**From:** Alsmeyer, Eric C CIV USARMY CESAW (USA) <Eric.C.Alsmeier@usace.army.mil>  
**Sent:** Thursday, March 9, 2023 2:08 PM  
**To:** Euliss, Amy  
**Cc:** Sawicki (Gannett Fleming), Jeremy P; Matthews, Monte K CIV USARMY CESAW (USA)  
**Subject:** [External] RE: U-2579AB mod, Site 18; DA# SAW-2017-02112, Winston-Salem Northern Beltway\_Forsyth  
**Attachments:** Rev\_SITE 18 U-2579AB Forsyth Modification 2023-02-28.pdf; U-2579AB UC PLANS REVISED SHEET UC-15.pdf  
Amy:

**North Carolina Division of Water Resources  
Transportation Permitting Unit  
In-Field Minor 401 Water Quality Certification  
Modification**

Water Quality Certification No. 004131; Project No. 19980260  
DWR Staff: Dave Wanucha, Winston Salem Regional Office  
Project: Winston Salem Northern Beltway, Eastern Section; U-2579AB, Permit Site 18.  
DOT Division 9 in Forsyth County  
DOT Staff: Amy Euliss and Jeremy Sawicki  
ACE Staff: Eric Alsmeyer and Steve Brumagin

**PERMIT DRAWING**  
**SHEET 63 OF 78**

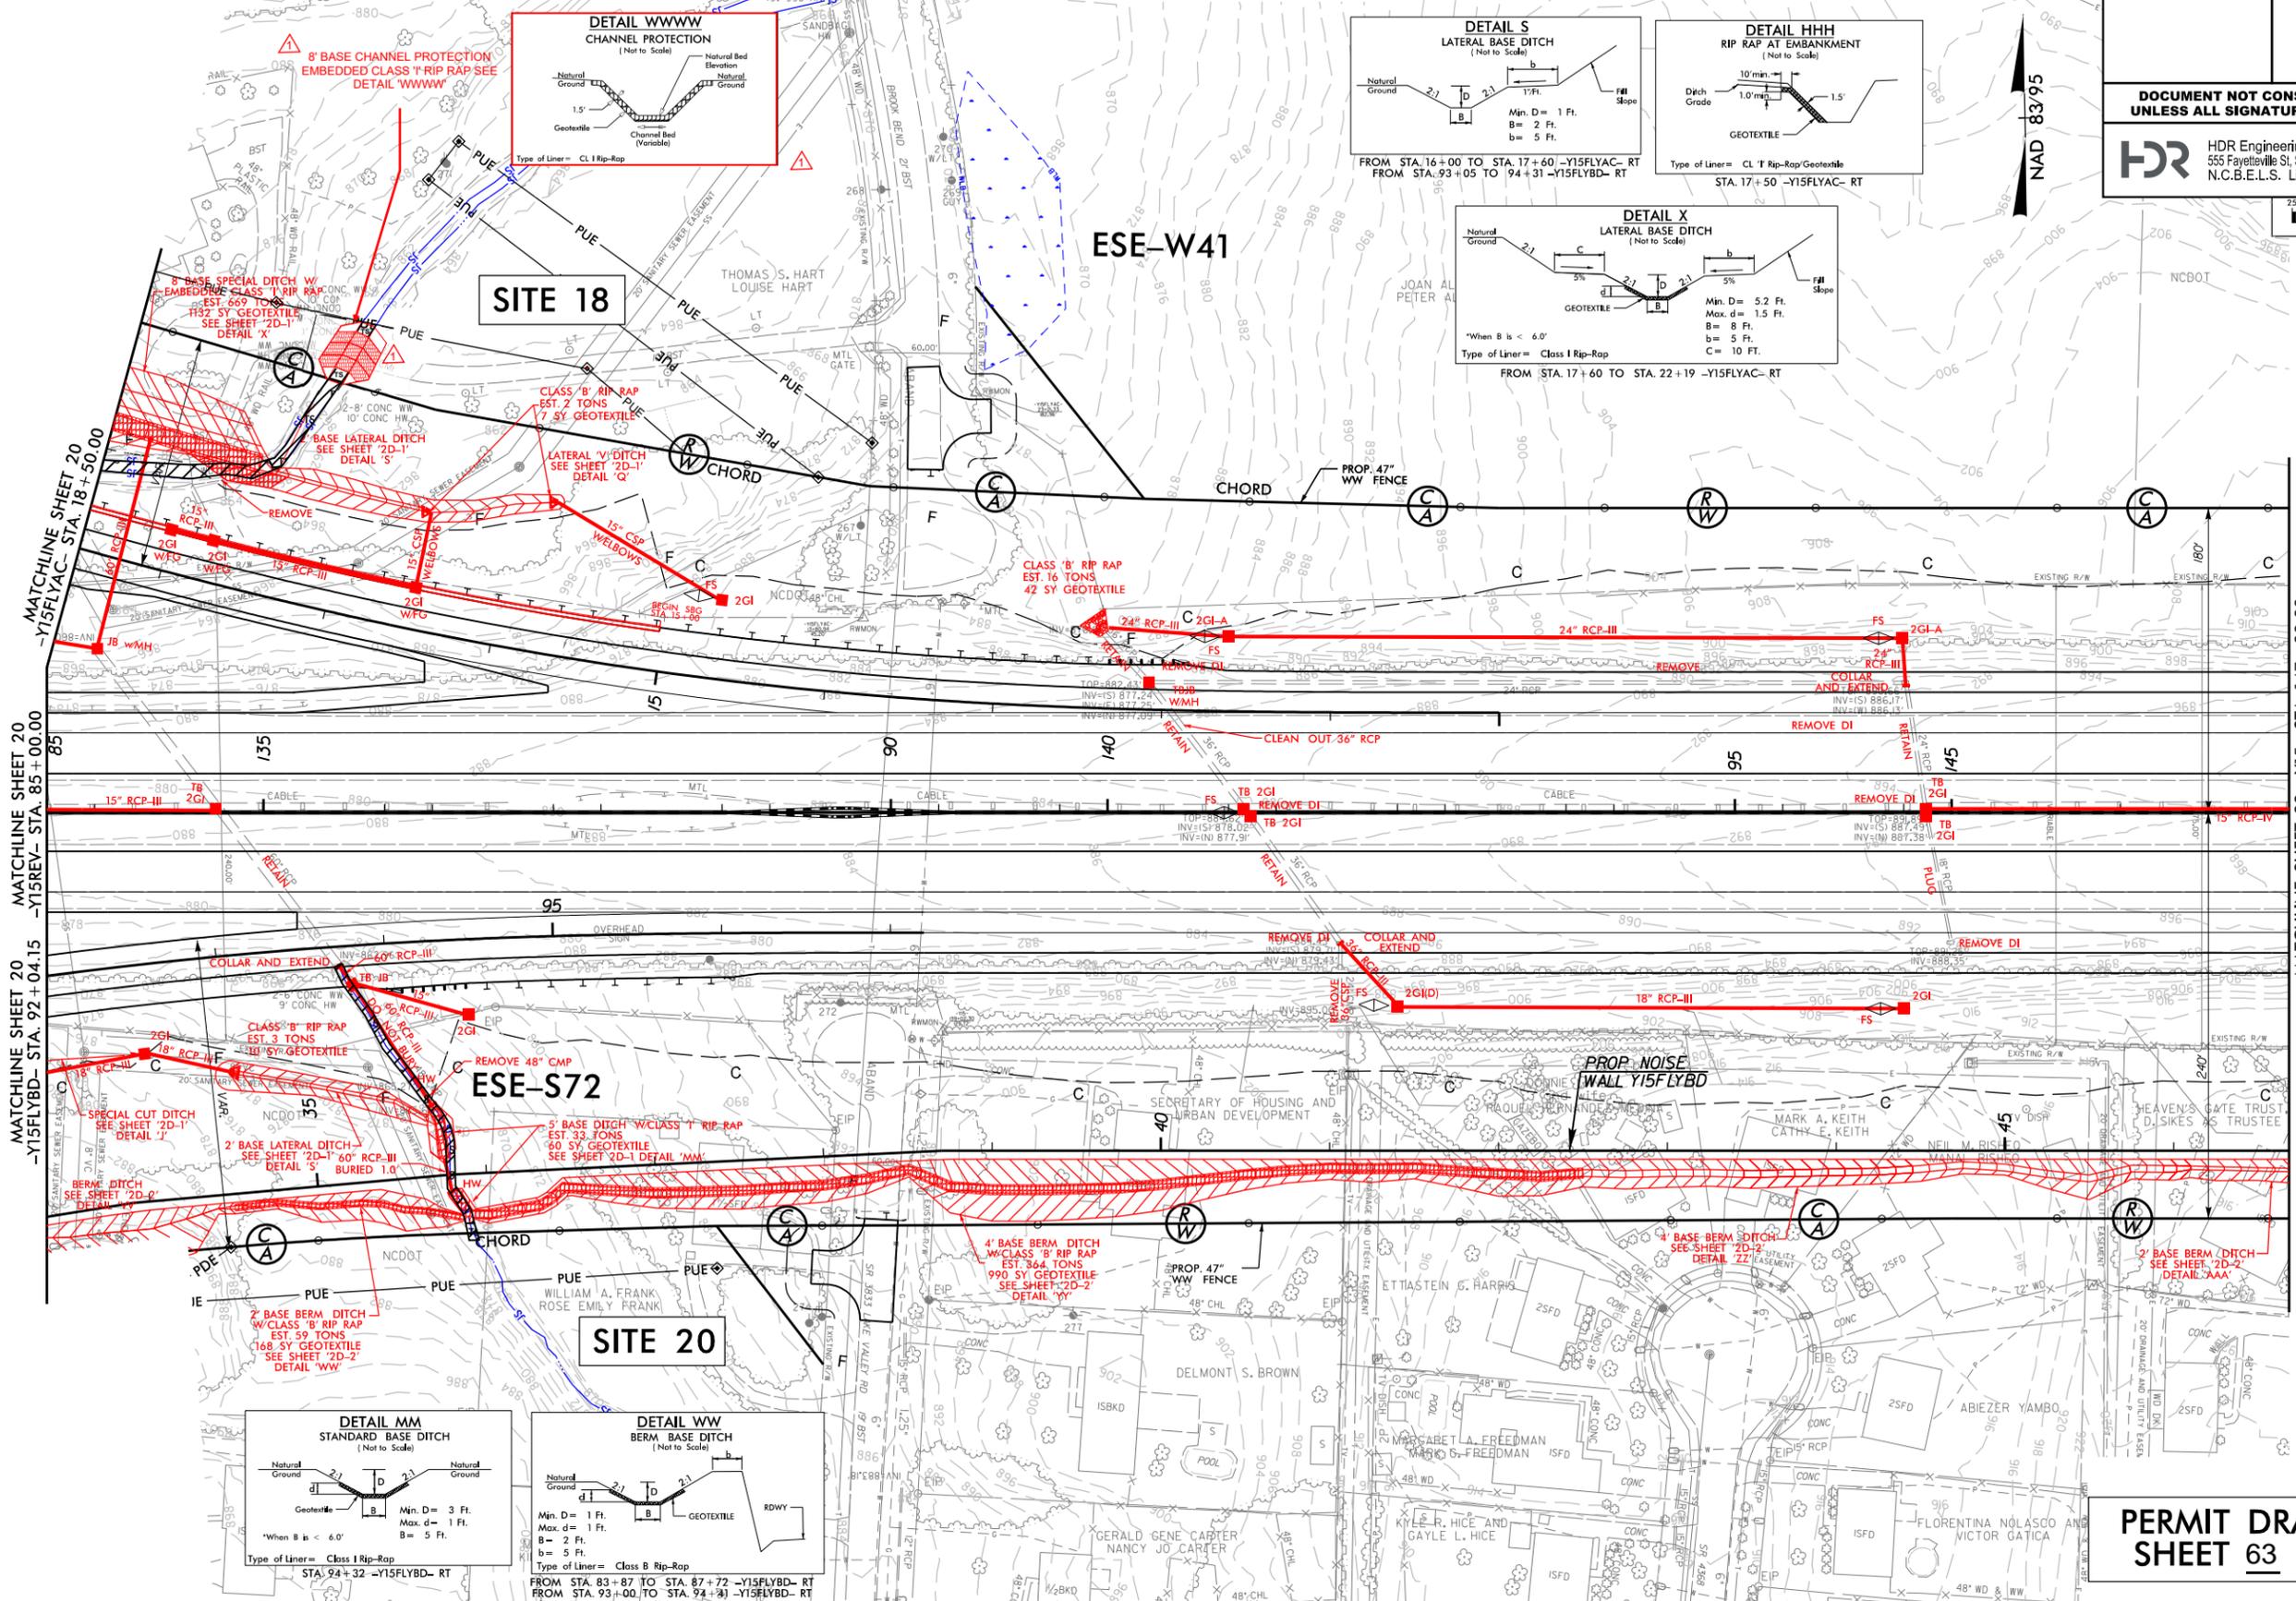
The purpose of this modification is to obtain regulatory approval for additional impacts associated with the installation of a sewer line. At Permit Site 18, there is an existing 96" CMP that runs under a driveway that is no longer in use. The driveway is on the west side of Brookbend Road and runs parallel to existing I-40. The 96" pipe will be removed, and a sewer line will be installed under the streambed where the pipe currently sits. DOT will need to stabilize the stream within the footprint of the existing pipe by sloping the banks back at 2:1 and armoring both the bed and banks with Class I rip rap. The width of the restored channel will be approximately 8' and will match the width of the existing stream and the downstream stream relocation. The pipe removal and sewer line installation will result in 40' of permanent impacts that do not result in a loss of water and thus no mitigation required. DOT will need to dewater the stream while the pipe is being removed and the sewer line is installed. This will result in approximately 50' of temporary impacts to the stream.

Next Page. Sketch on next page is a section of Permit Drawing Sheet 63 of 78 of U-2579AB.

The Corps has completed the evaluation of your request and has determined that it is appropriate and reasonable, and no public notice is required for this modification. Therefore, the permit is modified as requested, and described above, and as shown on the enclosed Revised Permit Drawing sheet 21, and Utility Plan sheet UC-15.
